GO2-21-108

Subject: **COLUMBIA GENERATING STATION, DOCKET NO. 50-397
RESPONSE TO REQUEST FOR ADDITIONAL INFORMATION
RELATED TO LICENSE AMENDMENT REQUEST TO ADOPT TSTF-
439, "ELIMINATE SECOND COMPLETION TIMES LIMITING TIME
FROM DISCOVERY OF FAILURE TO MEET AN LCO"**

RESPONSE TO REQUEST FOR ADDITIONAL INFORMATION

Figure associated with Example 2 of TSTF-439

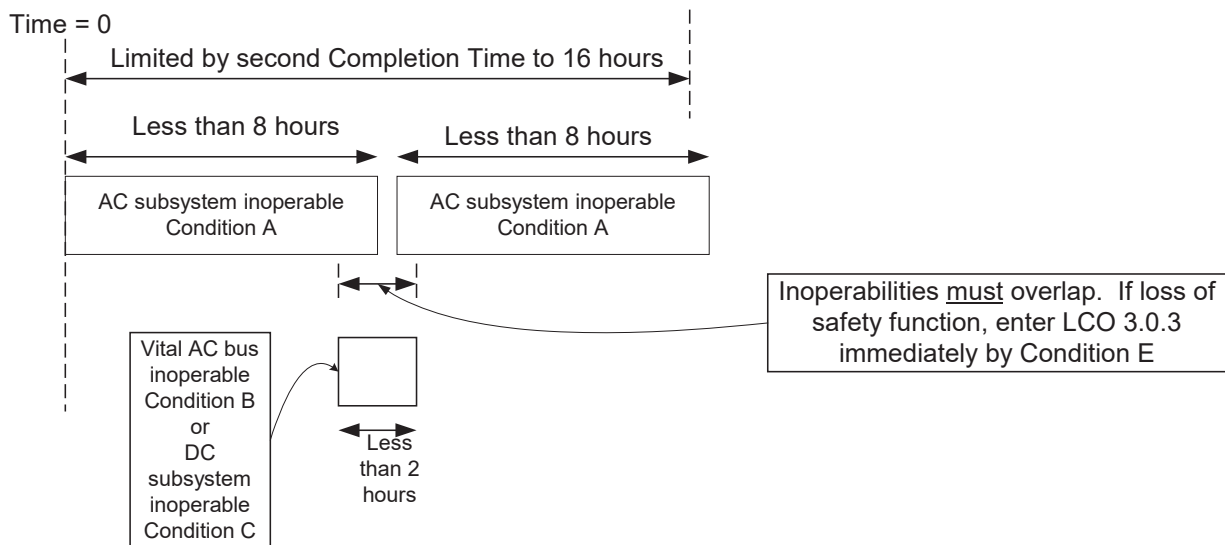
The licensee proposes to delete the Second CT associated with TS LCO 3.8.7 "Distribution Systems – Operating", Required Action A.1 and Required Action B.1 (TS pages 3.8.7-2 and 3.8.7-3) which currently states, "AND 16 hours from discovery of failure to meet LCO 3.8.7.a or b." This particular CT appears to apply when LCO 3.8.7 a or b is not met, and the version of the Distribution Systems TS on which TSTF-439's changes are based does not contain an LCO structure divided into subparts in the manner of the LCO for Columbia TS 3.8.7. Please explain the variation and justify the applicability of TSTF-439 for the proposed deletion.

entry ongoing to bridge the period between the two entries of CONDITION A. The lack of a dedicated condition in Columbia's LCO 3.8.7 associated with inoperable AC vital busses does not change this logic since the completion time associated with inoperable vital buses is 2 hours in the standard TS. This 2-hour time is comparable to the 2-hour time associated with DC subsystems, Columbia's Condition B. Overlapping inoperabilities with 2-hour completion times will already result in less than 16 hours of total action time. As outlined below, the programs established as an acceptable basis for eliminating second completion times in TSTF-439 are present at Columbia and justify the deletion of Columbia's 16-hour second completion times.

Consistent with the justification provided in TSTF-439, the second completion time is not needed. Credit is taken for the Maintenance Rule and example 2 of TSTF-439. Should any overlapping inoperabilities that result in a loss of safety function occur (TS 3.8.7, CONDITION F), a plant shutdown in accordance with LCO 3.0.3 is required (TS 3.8.7, REQUIRED ACTION F.1).
